Preservation Department – Item 1, LPC-26-03280

138-154 St. Felix Street, aka 11-21 Hanson Place

144 ST. FELIX STREET
ADAPTIVE-REUSE & ENLARGEMENT
STREKTE

LPC Certificate of Appropriateness Design Update

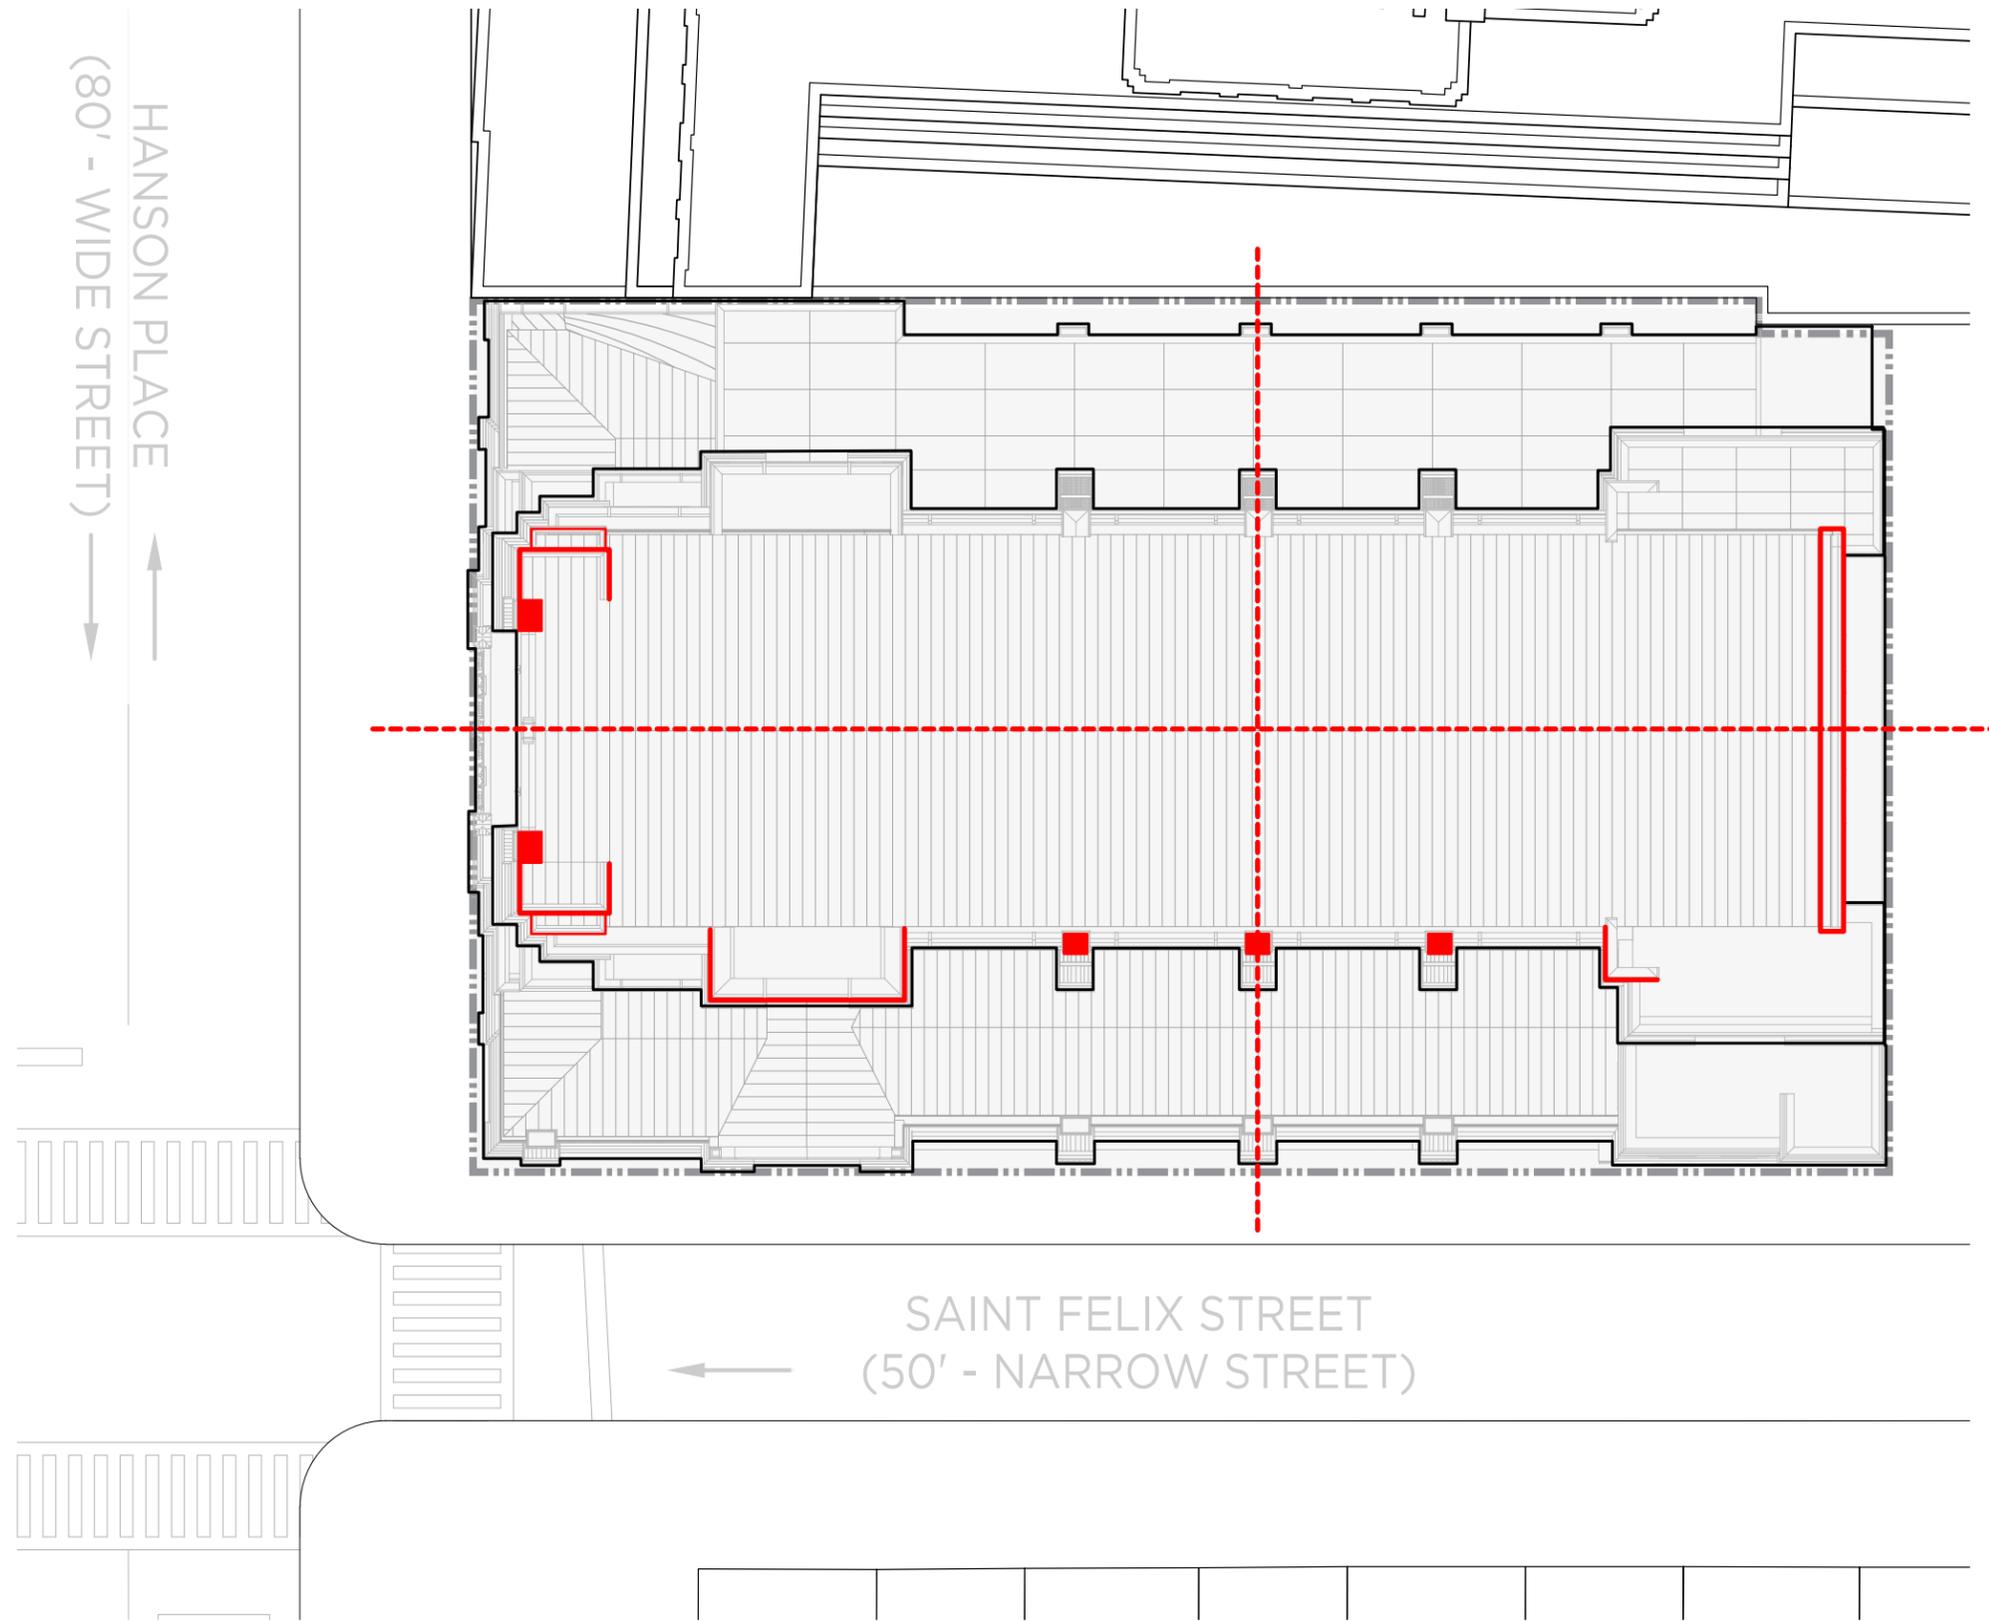
**Strengthen Enlargement's Relationship
to Church's Symmetries**

Reduce building height to 285' Datum

Incorporate Existing North Facade Roof Profile

Create a Transition between Church & Enlargement

Strengthen Enlargement's Relationship to Church's Symmetries

Reworked the massing to align with the governing geometries of the Church.

Simplified massing steps and introduced cast stone piers to relate to fenestration of the Church.

Reduce building height to 285' Datum

Reduced Building height to 285', and introduced symmetrical setbacks to the East Elevation.

Incorporate the Existing North Facade Roof Profile

Added Roof Profile to the new north facade to match existing and preserved Existing Rose Window.

Create a Transition between Church & Enlargement

Introduced a double height recess at first two floors above the Church to create a visual separation while also adding buttressing to the new brick piers to further relate to the church expression
